Subject: Czar Coal Corporation – Scaffold Lick Branch Coarse Refuse Storage Site (Kentucky Division of Mine Permits Permit No. 880-8002 A4) and Big Sandy Regional Airport Runway Extension (District Permit No. LRL-2008-00226)

Subject: Czar Coal Corporation – Scaffold Lick Branch Coarse Refuse Storage Site (Kentucky Division of Mine Permits (KDMP) Permit No. 880-8002 A4) and Big Sandy Regional Airport Runway Extension (Corps Permit No. LRL-2008-00226)

The U.S. Environmental Protection Agency (EPA), Region 4, has reviewed Czar Coal Corporation's proposed Scaffold Lick Branch Coarse Refuse Storage Site project in Martin County, Kentucky. The proposed project is the fourth amendment (KDMP Permit No. 880-8002 A4) to an existing Surface Mining Control and Reclamation Act (SMCRA) permit for Czar Coal's Pinnacle Processing Preparation Plant and associated areas, and includes the construction of an additional coarse refuse fill (Refuse Fill No. 2) and borrow areas, and an existing sediment pond (Pond 22). Impacts include 2,012 linear feet (lf) of intermittent and ephemeral jurisdictional streams and 0.69 acres of jurisdictional wetland. The refuse fill will abut the Big Sandy Regional Airp

Staged Construction Diagrams

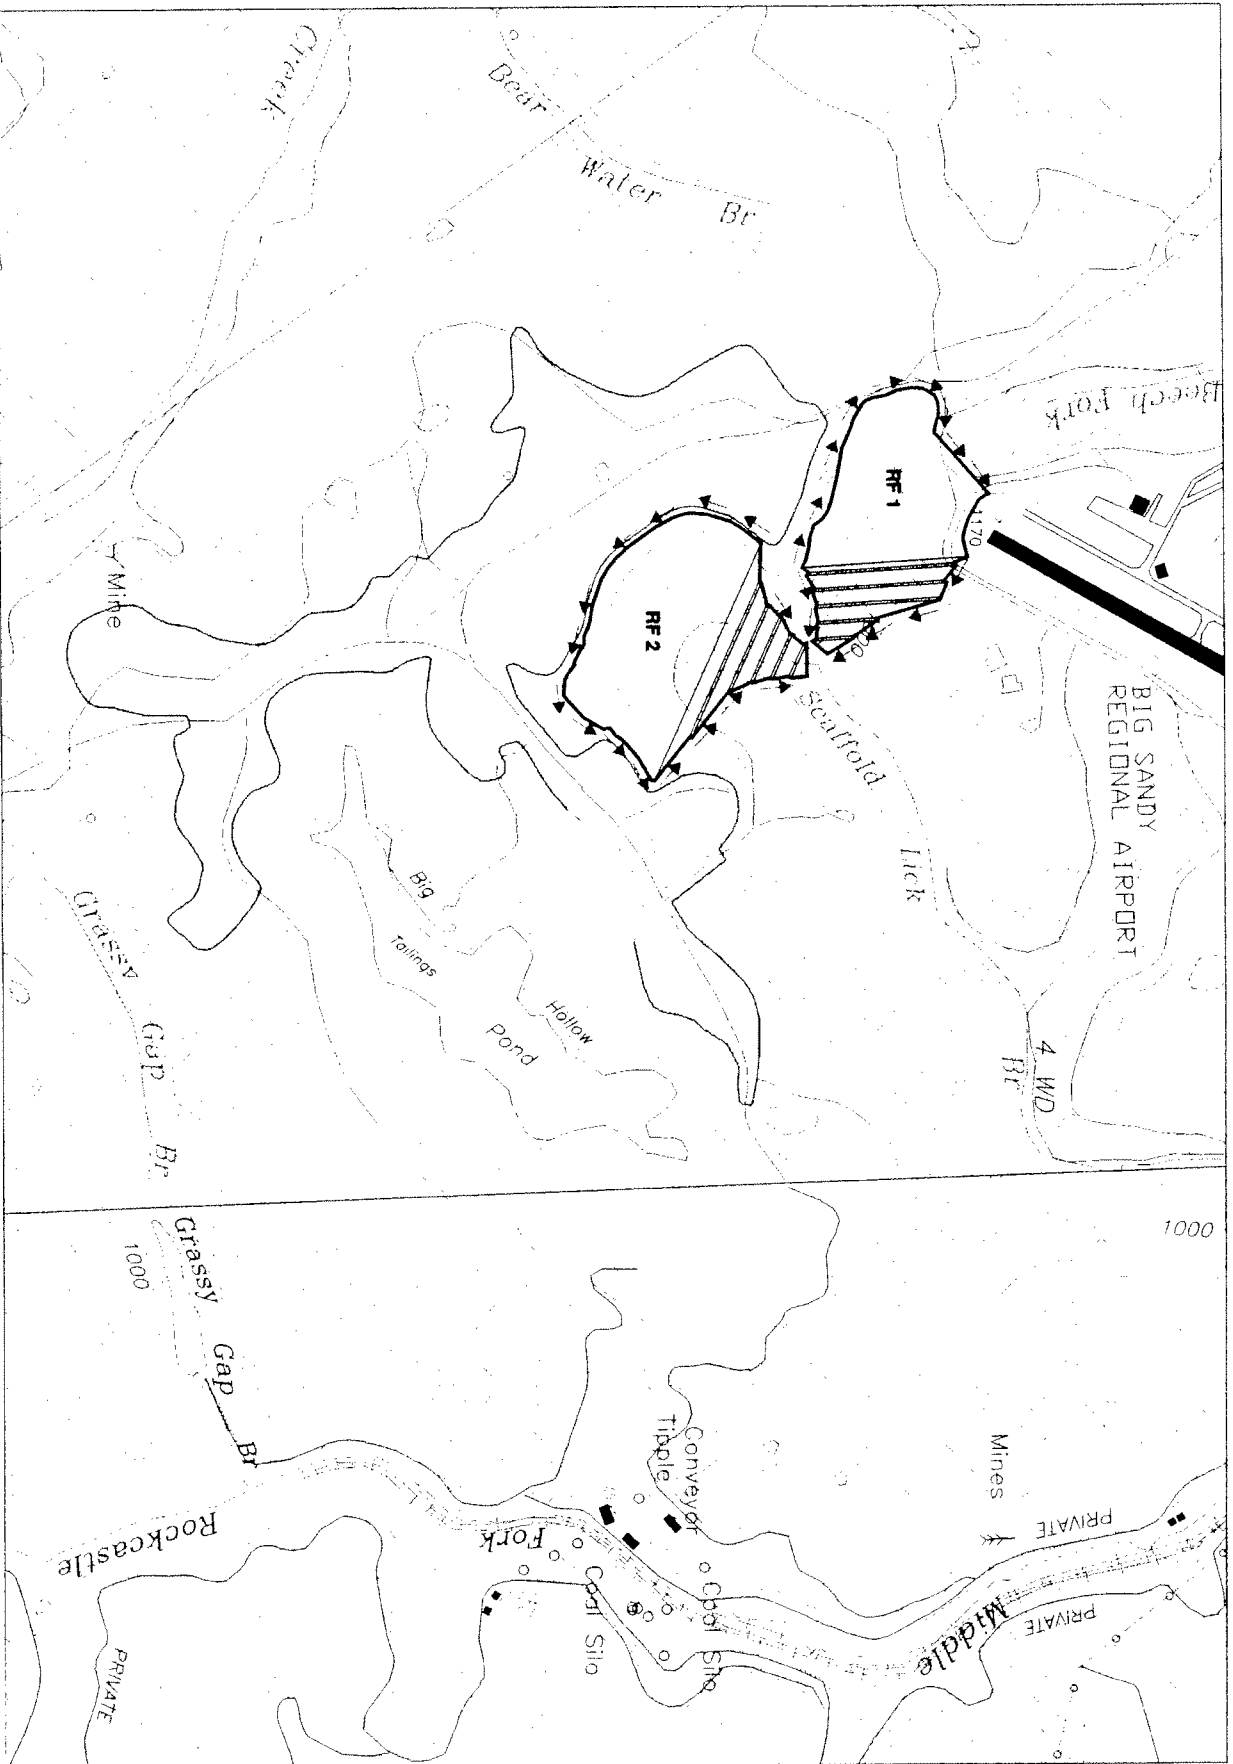
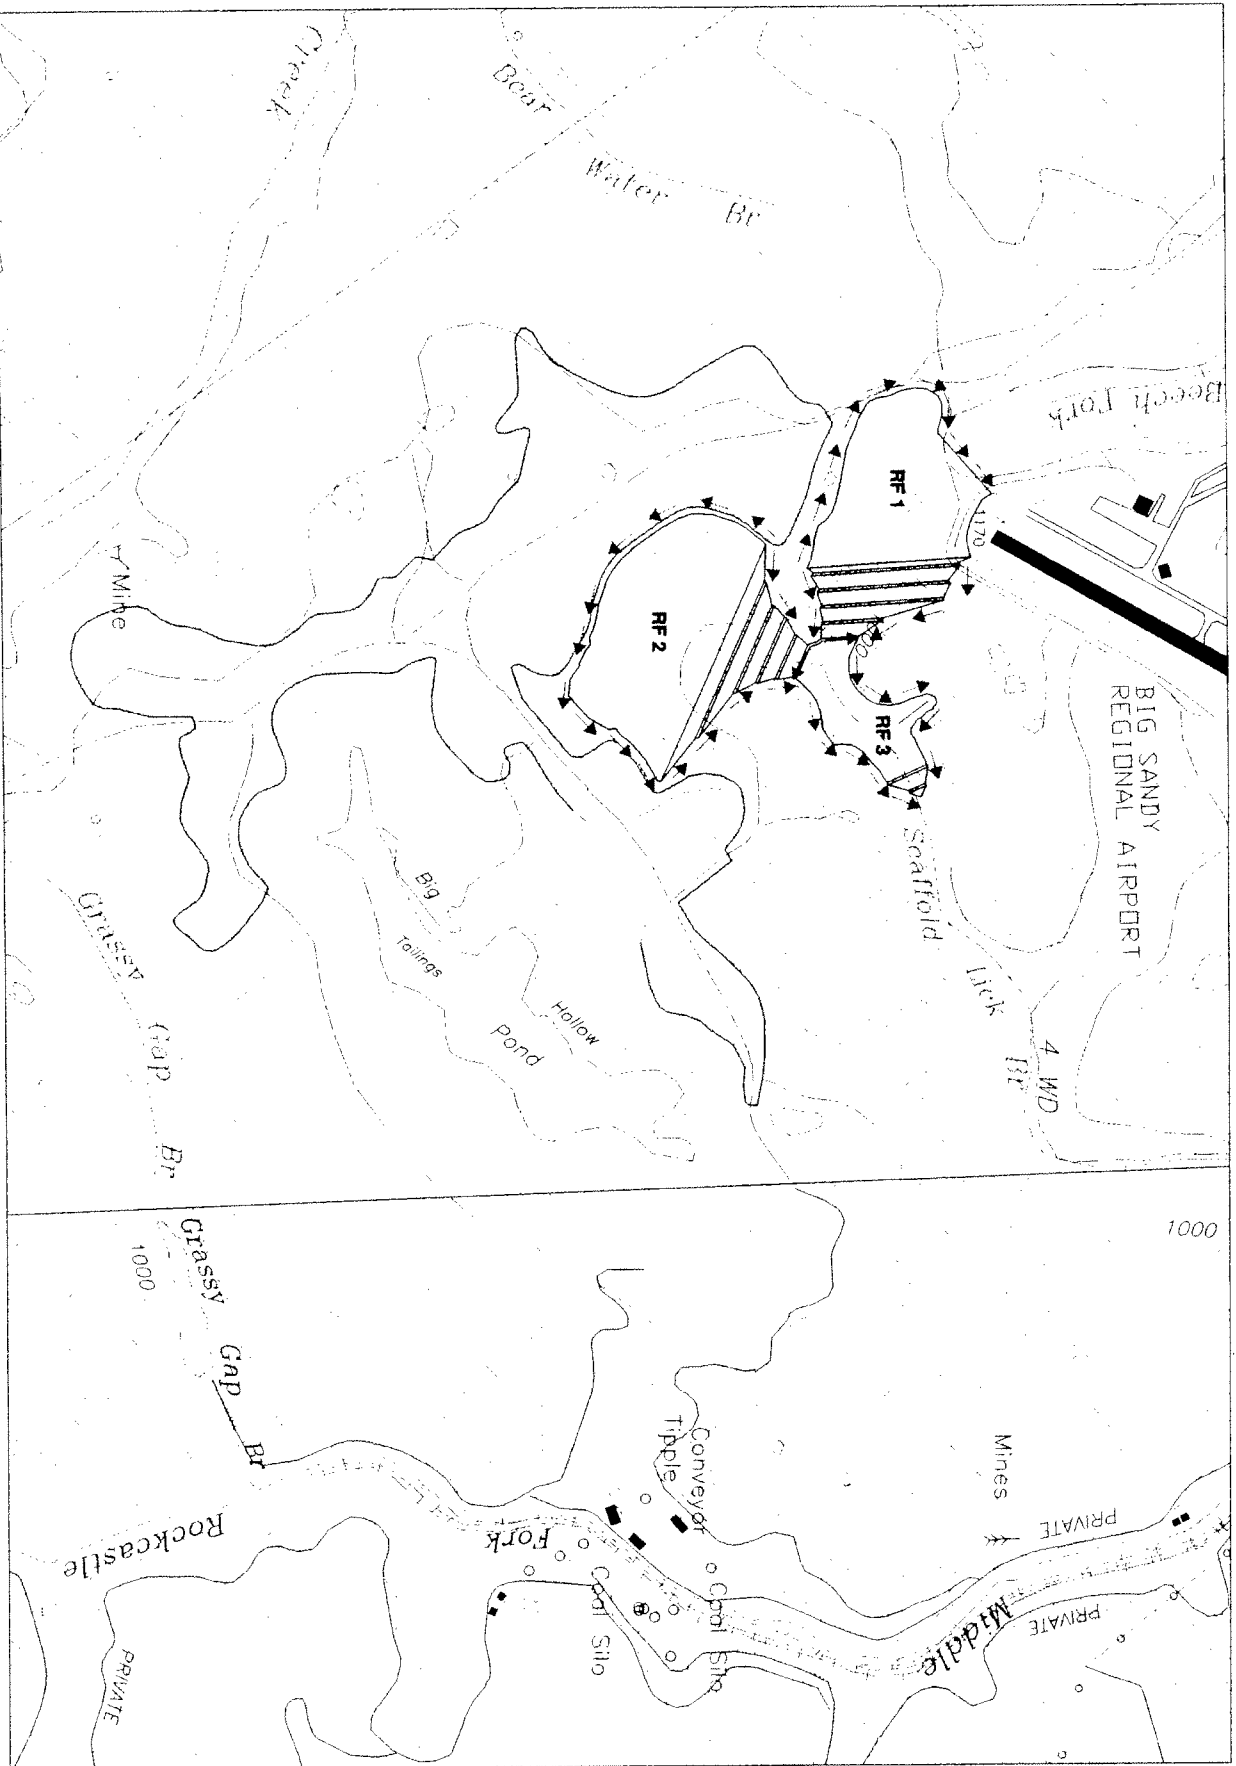
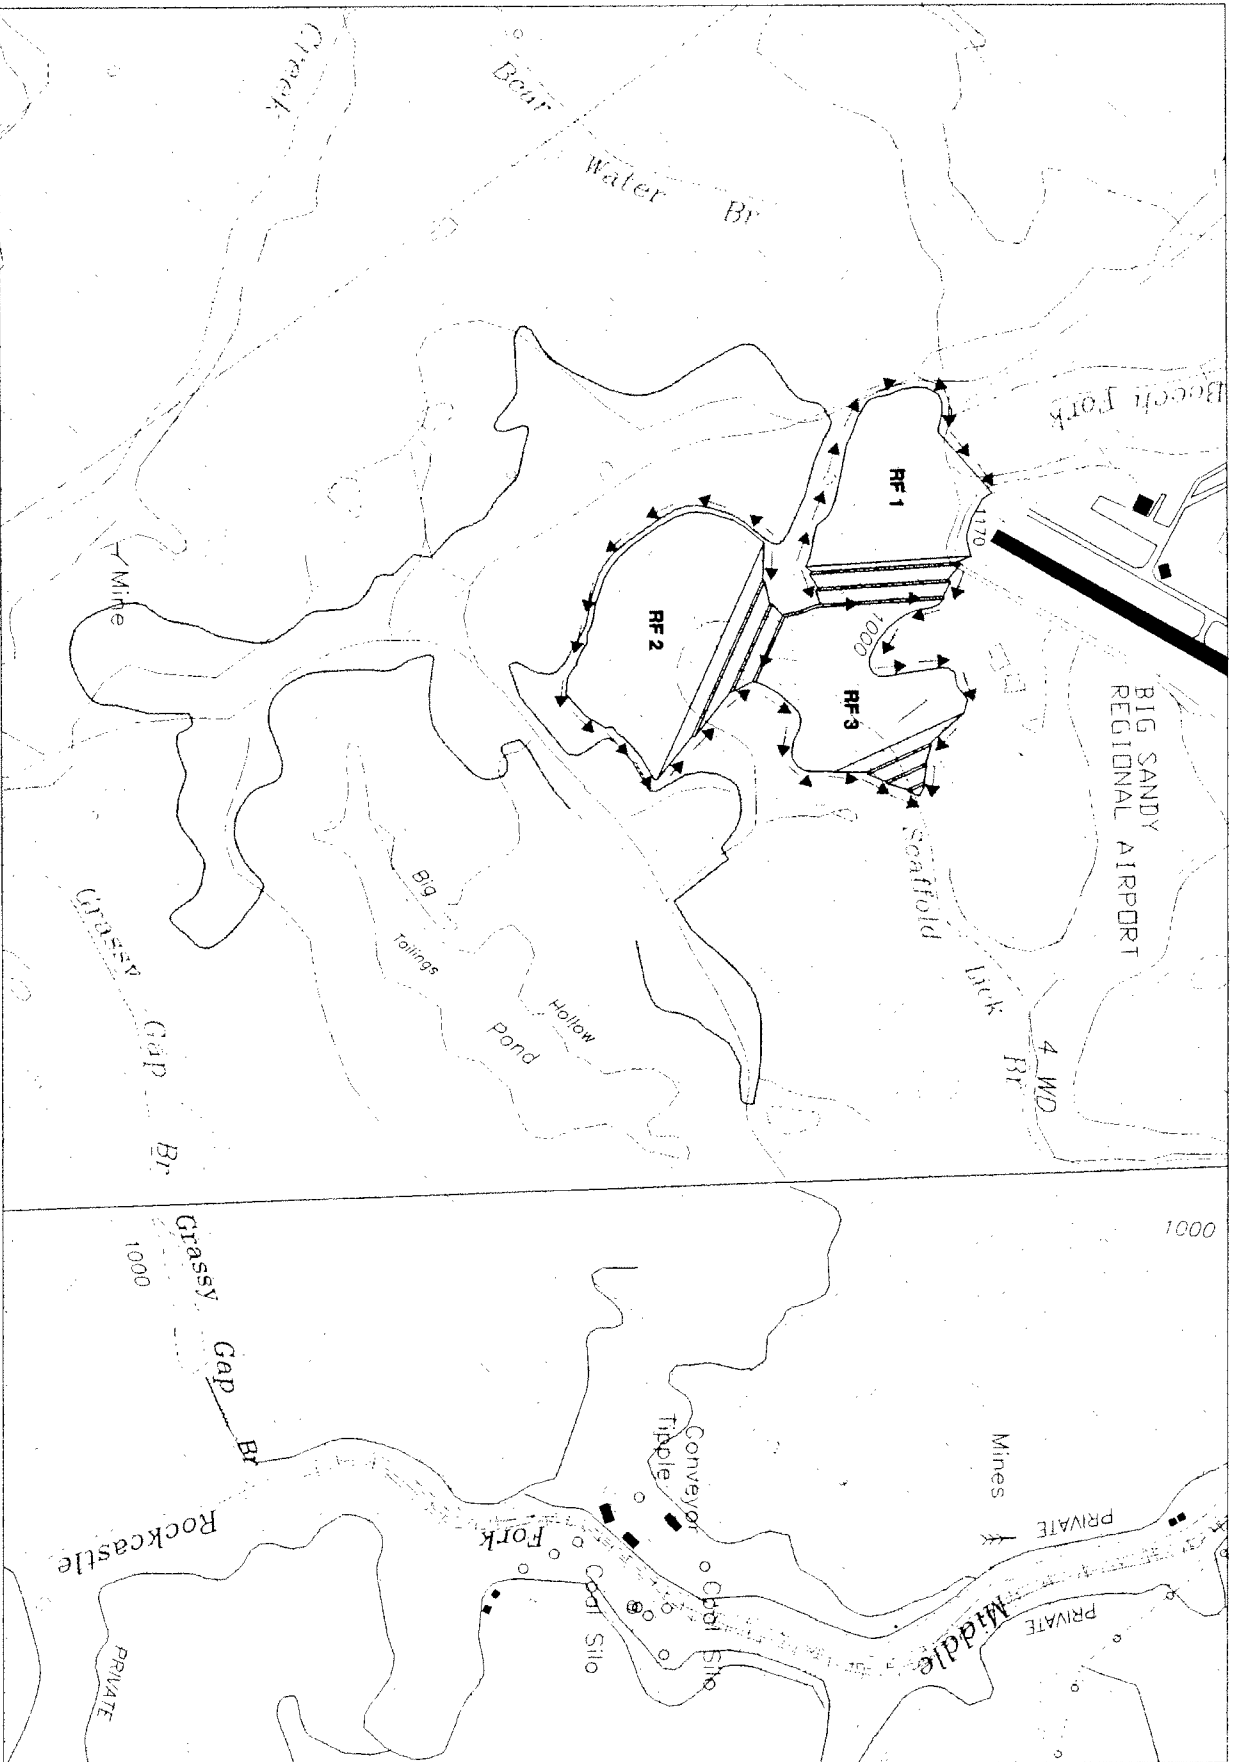
- using a 'staged' construction approach to achieve the desired refuse fill storage capacity (see Enclosure 2). In this approach the applicant completes Stage 1 by constructing a 'stand alone' refuse fill in the right fork of Scaffold Lick Branch (RF1 in Enclosure 2). This initial stage allows the applicant to store coarse refuse material, while fulfilling the applicant's project purpose to expeditiously construct the BSRA runway expansion. Stage 2 consists of placing a 'stand alone' fill in the left fork of Scaffold Lick Branch (RF2 in Enclosure 2). Stage 3, the final stage, consists of constructing the refuse fill from the proposed design downstream toe location, located in the mainstem of Scaffold Lick Branch, and tying it to the previous 'stand alone' refuse fill configurations developed in Stage 1 and Stage 2. This staged approach to the construction of the refuse fill will allow EPA to evaluate water quality impacts incrementally as construction progresses, which ultimately should allow for improved implementation and potential success of the adaptive management plan;
